# Access Compliance Report

## Public Rights-of-Way

### (Curb Ramps)

| Intersection ID: 11823 | Main Street: N_ALEXANDER_ST | Cross Street: E_15TH_ST | Location:              | N                  |

| ADA ID: A3722083331E   | Ramp Type: Perp             | Initial Pass/Fail: Fail | Overall Compliance: No | Severity Score: 10 |

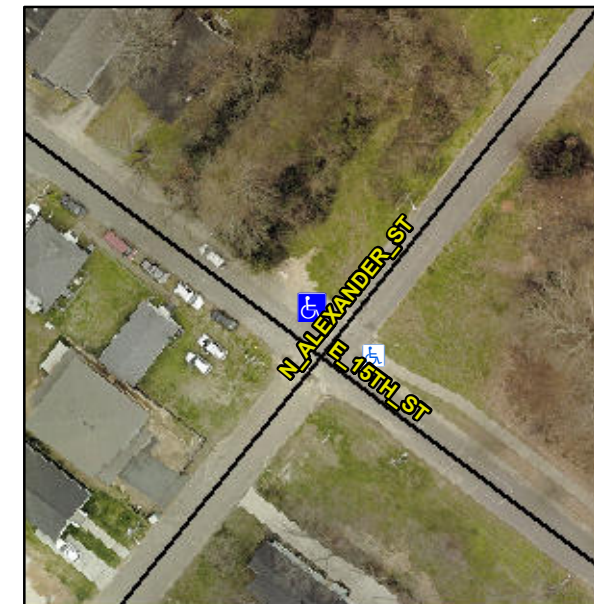
**Not Found, R304.5.1, R304.5.3**

| Compliance | Description           | Data  | Compliance | Description                 | Data |
|------------|-----------------------|-------|------------|-----------------------------|------|
| N/A        | Ramp Length (in)      | 75.0  | Yes        | Ramp Slope (%)              | 6.7  |
| No         | Ramp Width (in)       | 47.5  | No         | Ramp XSlope (%)             | 4.5  |

**Remove & Replace Entire Ramp.**
